ECE/TRANS/WP.29/GRE/2008/15
18 January 2008

Working Party on Lighting and Light-Signalling

Proposal for Supplement 2 to the 04 series of amendments to Regulation No. 48
(Installation of lighting and light-signalling devices)

Submitted by the expert from France */

FIGURE (see paragraph 6. 5.)

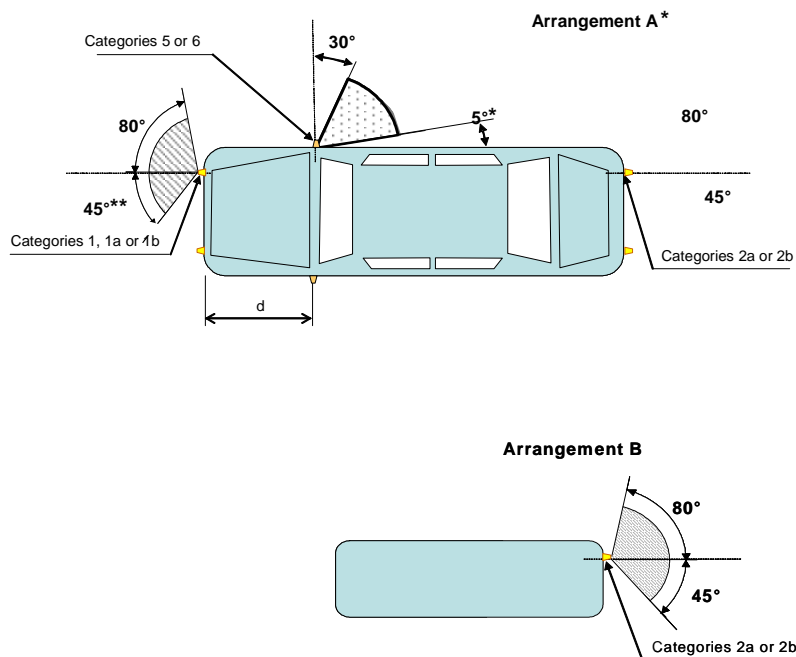
Paragraph 6.5.5.1., amend to read:

"6.5.5.1. Horizontal angles, (see figure below)

Vertical angles: 15° above and below the horizontal for direction-indicator lamps of categories 1, 1a, 1b, 2a, 2b and 5. The vertical angle below the horizontal may be reduced to 5° if the lamps are less than 750 mm above the ground; 30° above and 5° below the horizontal for direction-indicator lamps of category 6. The vertical angle above the horizontal may be reduced to 5° if the optional lamps are not less than 2,100 mm above the ground.

(*) The value of 5° given for dead angle of visibility to the rear of the side-direction indicator is an upper limit. $d \leq 1.80$ m(for M₁ and N₁ category vehicles $d \leq 2.50$ m).

(**) **The value of 45° for the front direction indicator maybe reduced to 20° under the HH line of this lamp."**

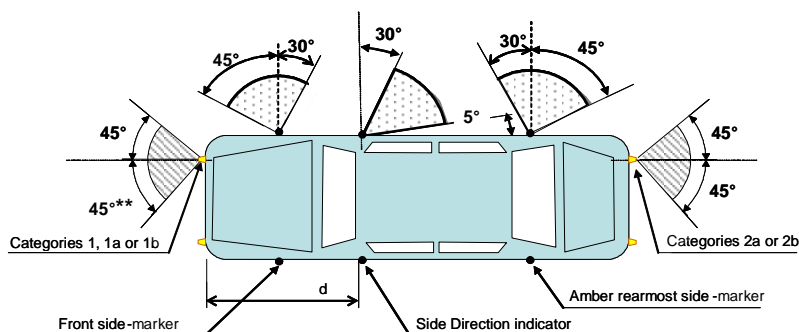
Paragraph 6.5.5.2., amend to read:

"6.5.5.2. or, at the discretion of the manufacturer, for M₁ and N₁ category vehicles (***):

Front and rear direction-indicator lamps, as well as side-marker lamps

Horizontal angles see figure below:

Vertical angles: 15°

(***) The value of 5° given for dead angle of visibility to the rear of the side-direction indicator is an upper limit. $d \leq 2.50$ m." (for M₁ and N₁ category vehicles $d \leq 2.50$ m)."
